DRESDEN NUCLEAR POWER STATION

UNIT 2

Supplementary Information

Special Report
of
Incident of June 5, 1970

FIGURE 1
DRYWELL WALL TEMPERATURE RESPONSE

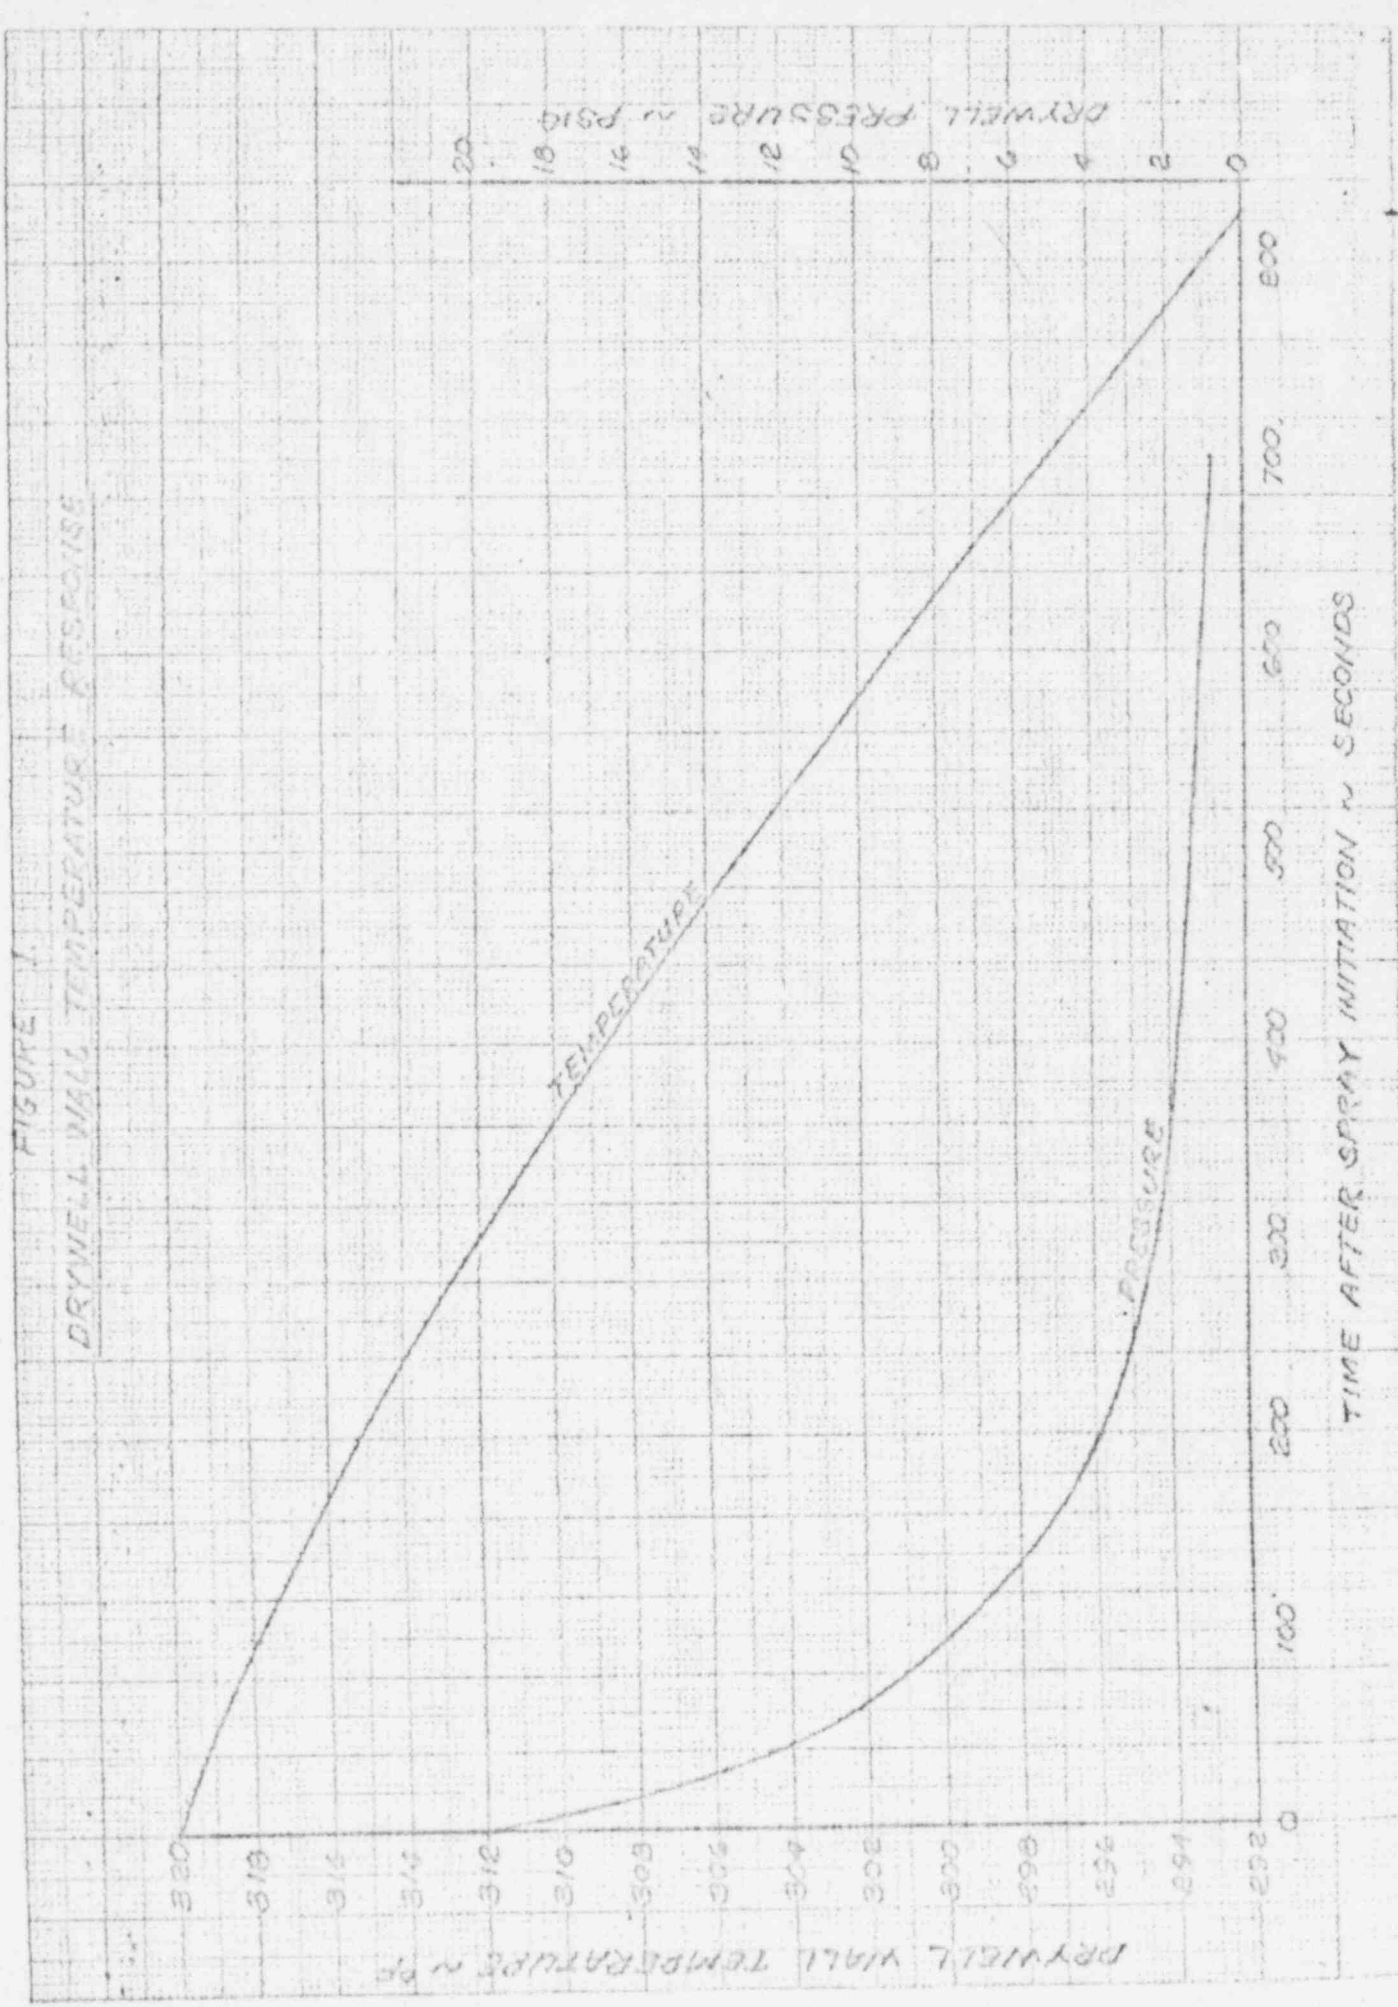
1. On page VII (6) special report of incident June 5, 1970, it is stated that a new design temperature of 320°F has been established for the primary containment. Previously the design temperature had been established at 281°F. Accordingly, provide analyses to show that the various structural elements, including penetrations, can withstand the effects of the high temperatures and provide the results of analyses to show that this new design temperature is the maximum temperature which could be experienced within the primary containment. Include the effect of containment spray operation in the analyses. In addition for equipment within the containment which is required to remain operational during such an incident as occurred on June 5, 1970, provide appropriate test results or other applicable data that demonstrates such components can withstand the incident environment. The effects of a high design temperature on the allowable primary containment leak rate should also be discussed.

If it is postulated that the containment spray was turned on after the drywell wall had heated uniformly to 320°F, the drywell pressure and wall temperature would respond as shown in Figure 1. After 10 minutes the containment pressure has dropped to about 1 psig and the wall temperature to 300°F. Again this combination of buckling load would be less than the design case. In fact, even if the temperature was still 320°F and the pressure as low as 0.2 psig, the buckling load would be no worse than the design case (281°F @ 0 psig). Finally as indicated in the incident report, at 320°F and 0 psig the safety factor compared to allowable loading is 2.0.

FIGURE 2. DYKESON 2 DRYWELL VENTING SYSTEM. (REVISED) 1970

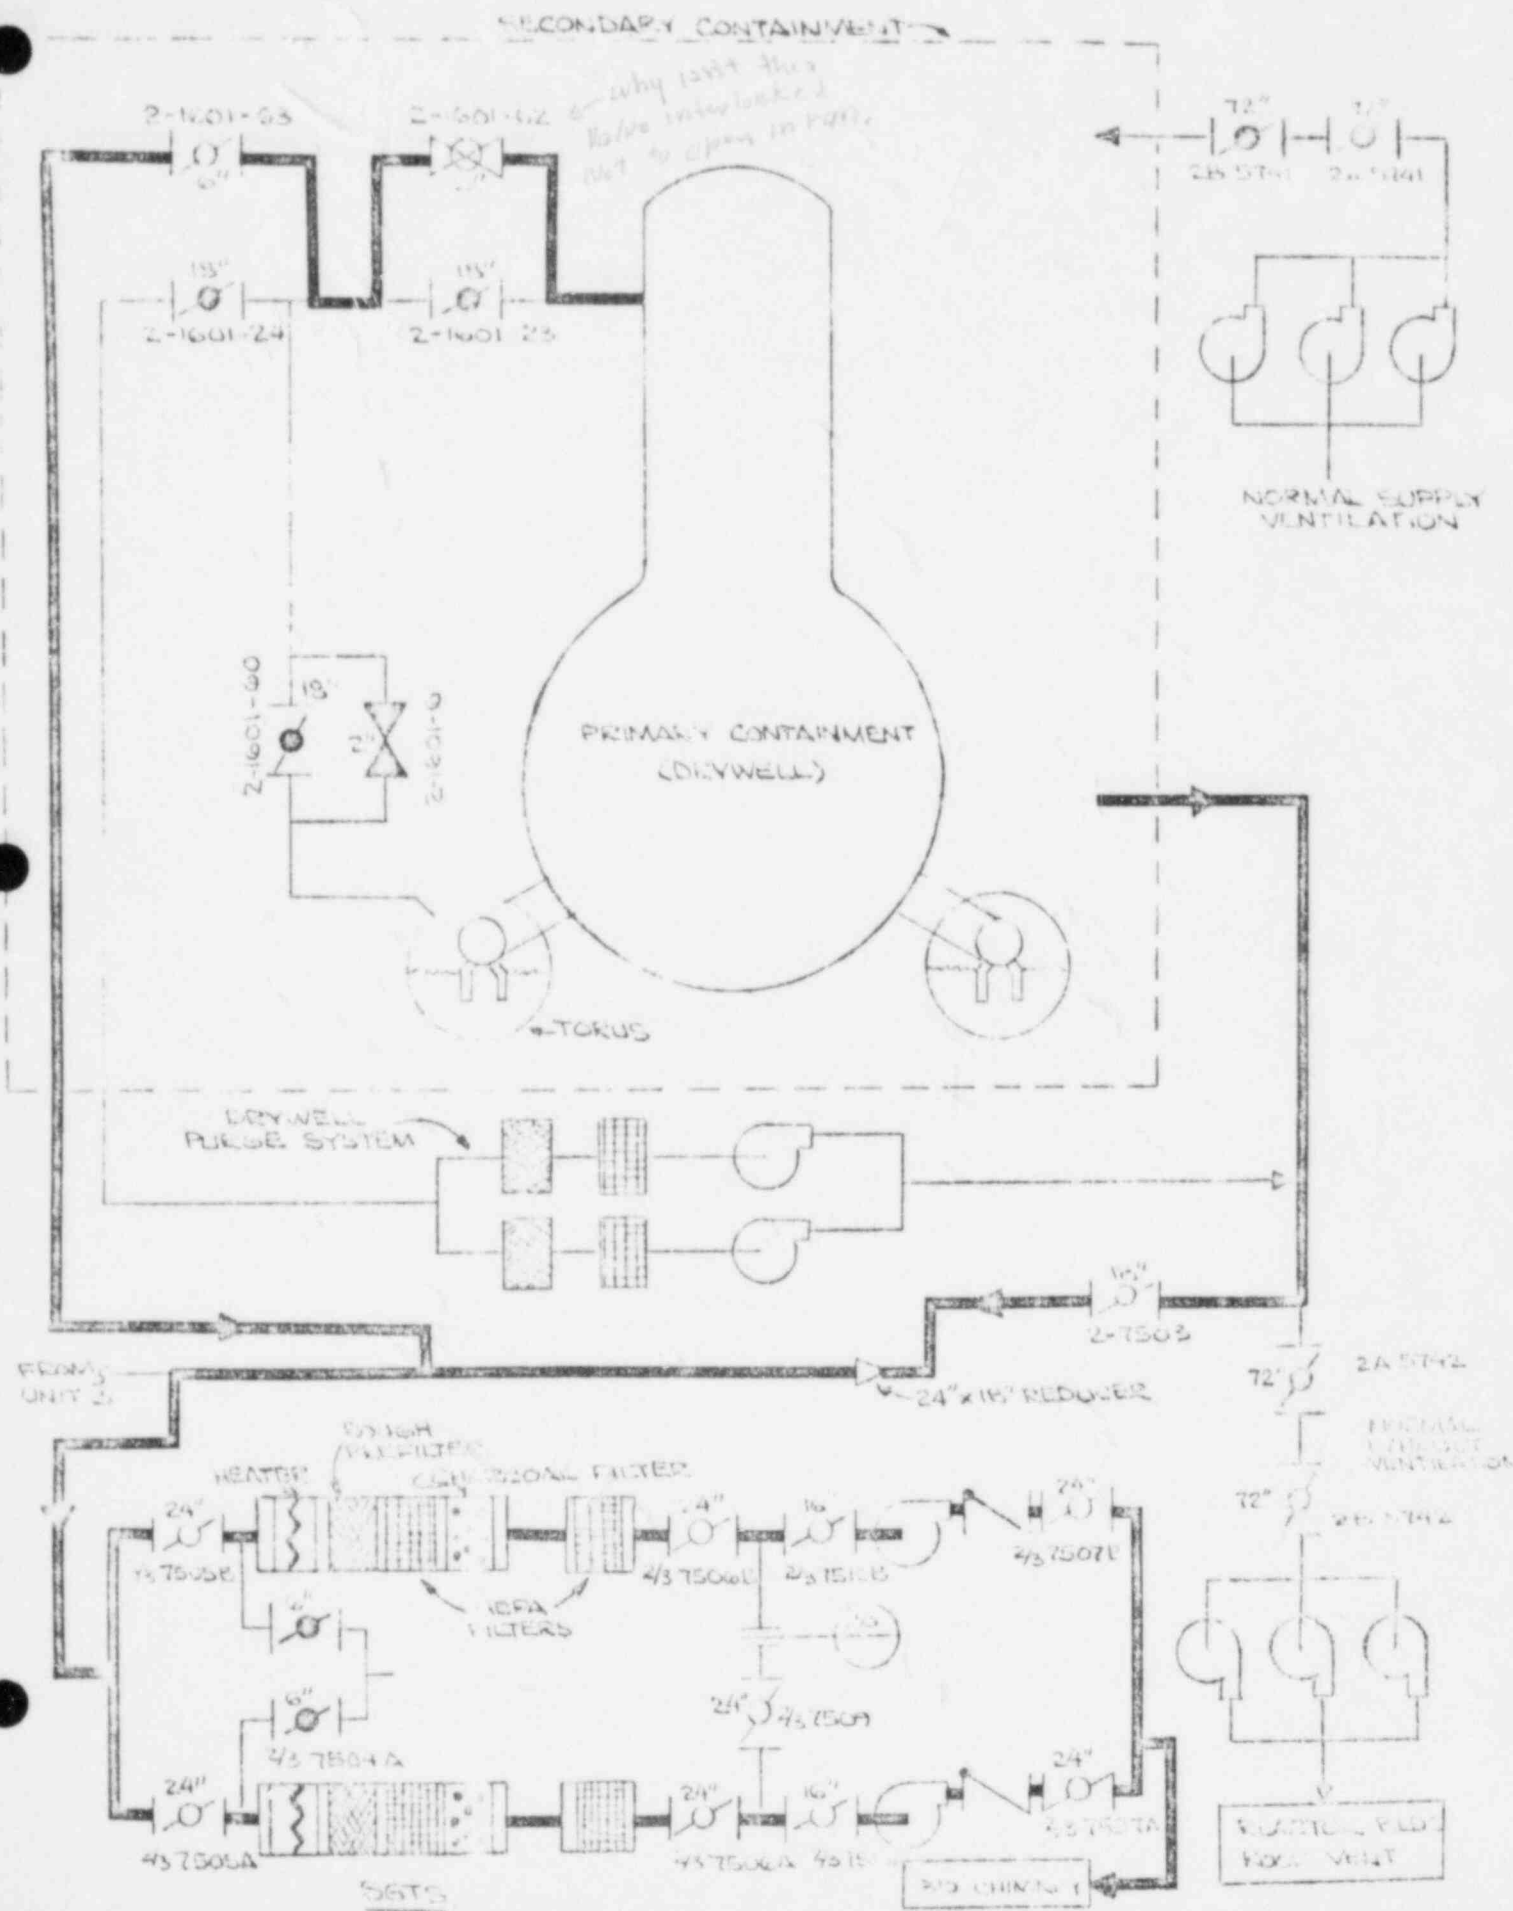
2. Following the incident the primary containment atmosphere was vented through the standby gas treatment system. The pressures and temperature, that the standby gas treatment system experienced during the venting operation are not stated in your report. These data should be provided and compared to the conditions for which the system was designed. In the event the design parameters were exceeded discuss the inspection and maintenance actions that were performed that assure that the system is now capable of performing its design function and that design parameters will not again be exceeded.

Also describe the revisions to procedures or equipment that have been implemented to prevent use of this system until the containment atmosphere is known to be within design conditions for the SGTS. The desirability of appropriate interlocks on the vent line isolation valve should also be included in the discussions as well as your plans to require operability of necessary instrumentation to evaluate the containment atmosphere to incident conditions. Redundancy aspects of such instrumentation should also be discussed.

A procedure has been issued titled "Primary Containment Post Incident Cooling and Depressurization." This procedure specifies the conditions under which the containment may be vented after an incident and also details the procedures to be followed for post incident cooling and depressurization. This procedure states that:

The containment isolation system prevents venting of the containment through the 18-inch line whenever the containment pressure is in excess of 2 psig. The 2-inch vent line is not included in the containment isolation system but is restricted in operation by the operating procedures as modified above.

FIGURE 6-1

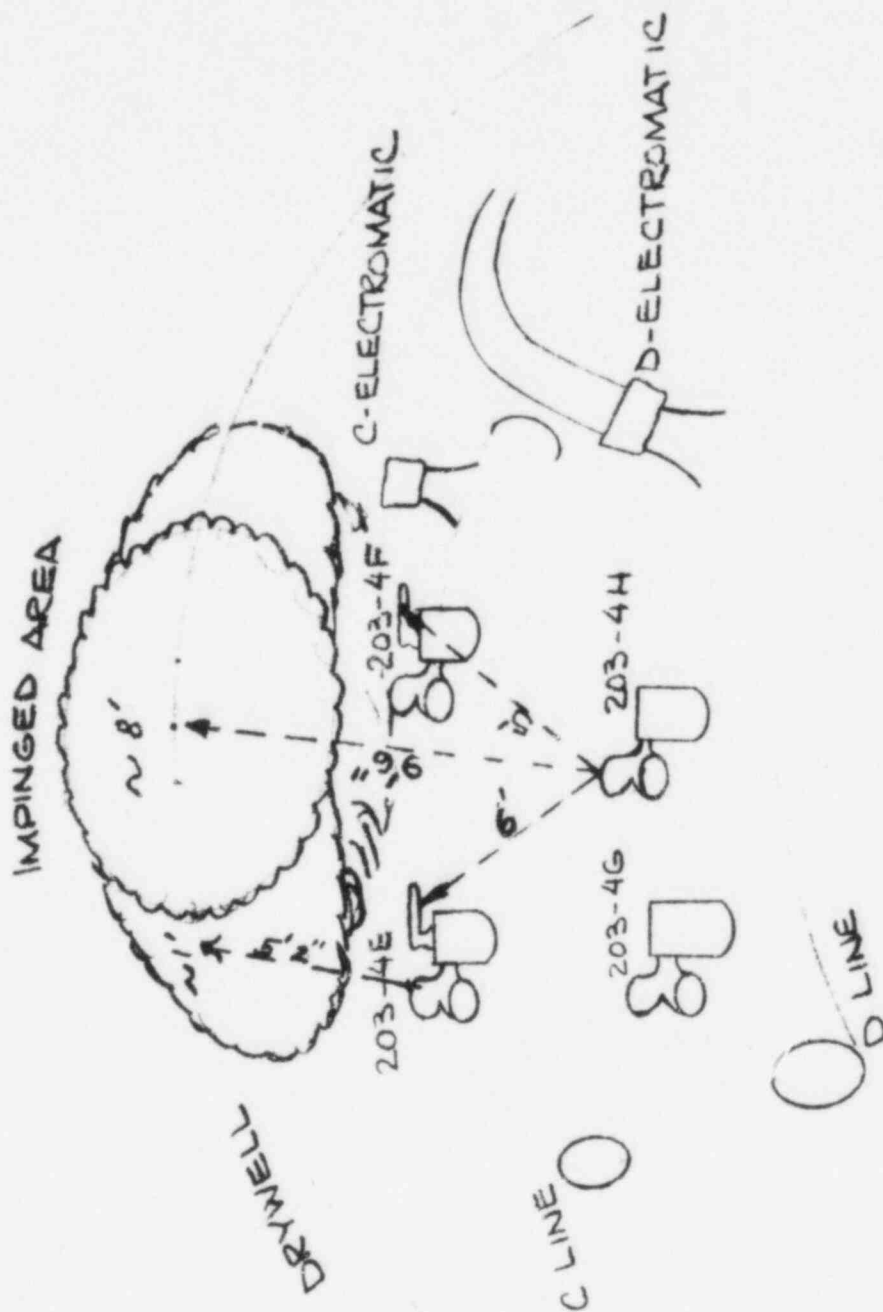
6. During the incident the steam discharged through the safety valves impinged on various components within the primary containment. Provide a sketch that shows which components were exposed to the steam jet and provide resulting pressure loadings to which such components were subjected. Relate these loadings to those included in design evaluations. Include in this evaluation the change (due to a heated valve and springs) in set points that could have resulted from the safety valves that were subjected to the steam jet.

A sketch that shows which components were exposed to the steam jet is shown in Figure 6-1.

The various components which were subject to the jet stream have been evaluated to determine the resulting pressure loading to which these components were subjected. The maximum stresses developed on any of the components occurred on the relief valve which was subject to a 4000 pound impingement load. This loading results in a maximum stress of 80% of code allowable.
